ARKANSAS NUCLEAR ONE - UNIT 1

IMPROVED TECHNICAL SPECIFICATIONS SUBMITTAL

**05/01/01 Supplement
Volume 2 of 2
(Sections 3.7 and 3.8)**

May 1, 2001

Figure 3.8.1

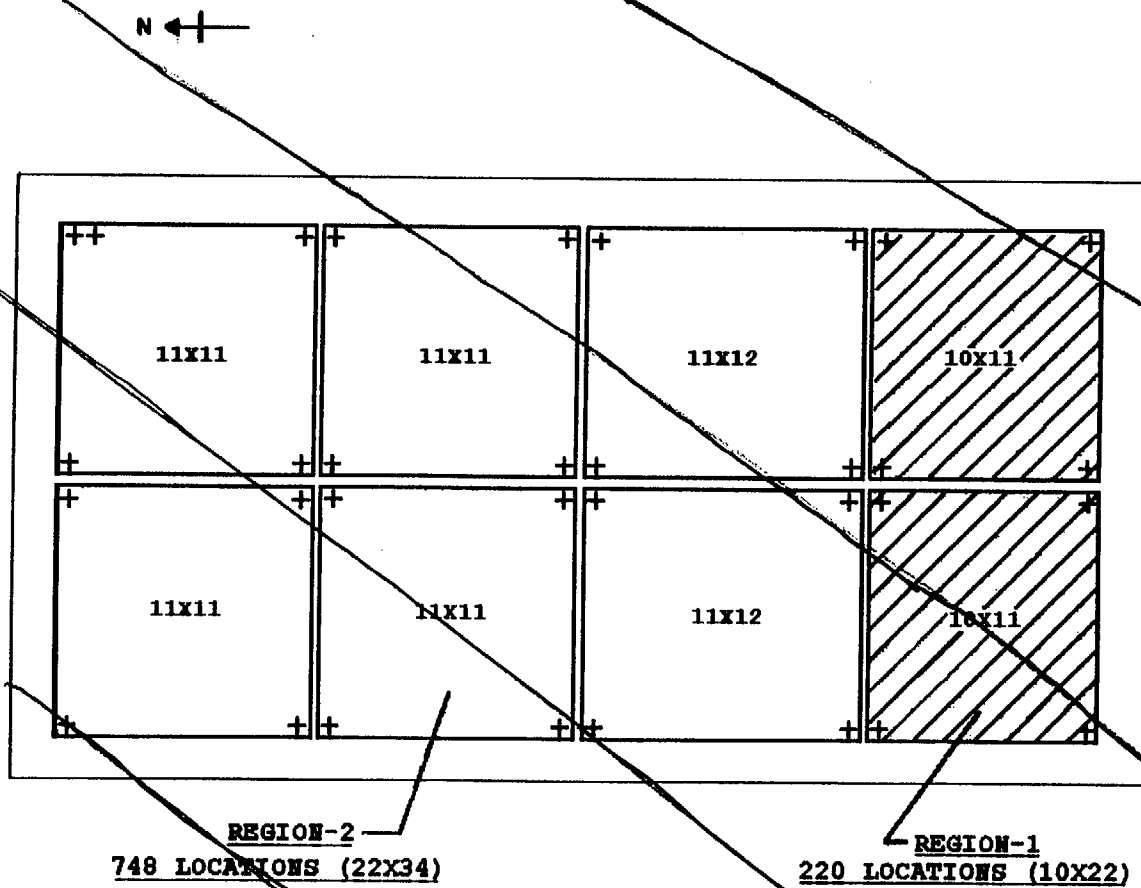
3.8.16 Storage in Region 2 (as shown on Figure 3.8.1) of the spent fuel pool shall be further restricted by burnup and enrichment limits specified in Figure 3.8.2. In the event a checkerboard storage configuration is deemed necessary for a portion of Region 2, vacant spaces adjacent to the faces of any fuel assembly which does not meet the Region 2 burnup criteria (non-restricted) shall be physically blocked before any such fuel assembly may be placed in Region 2. This will prevent inadvertent fuel assembly insertion into two adjacent storage locations. The provisions of Specification 3.0.3 are not applicable. LA3 SAR

<u>CTS Location</u>	<u>New Location</u>
3.7-31	Figure 3.8.1	SAR Fig. 9-53
3.7-15	Table 4.1-3, #4 w/Note (9)	TRM
3.7-19	4.5.1.1.2 (b)	TRM
	4.5.2.1.2 (c) (3)	TRM
	4.11.5	TRM
3.7-21

Figure 3.7.15-1

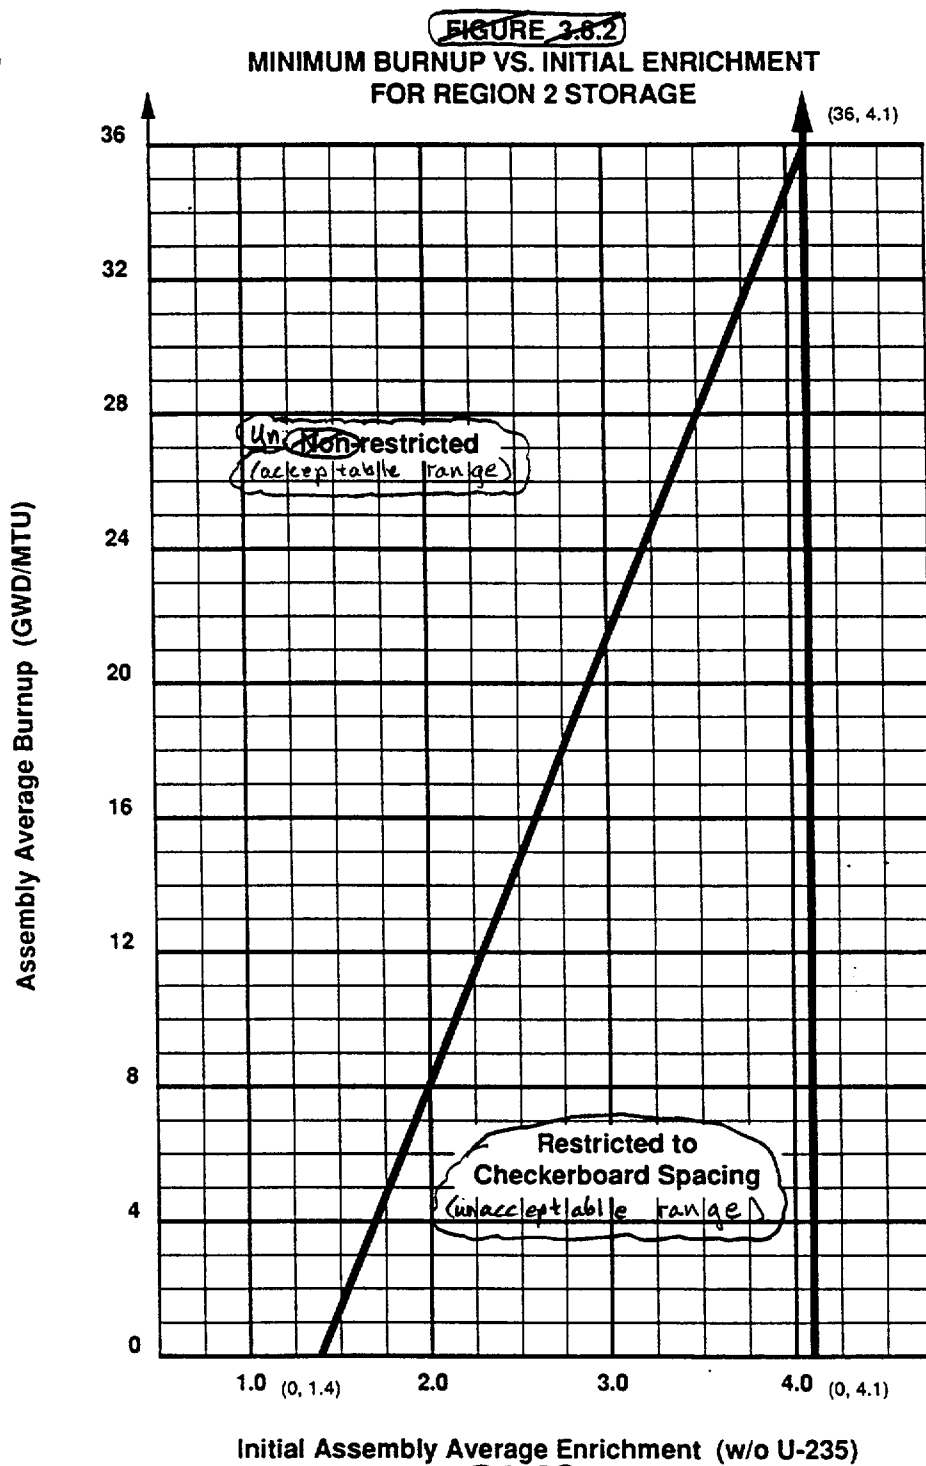
edit
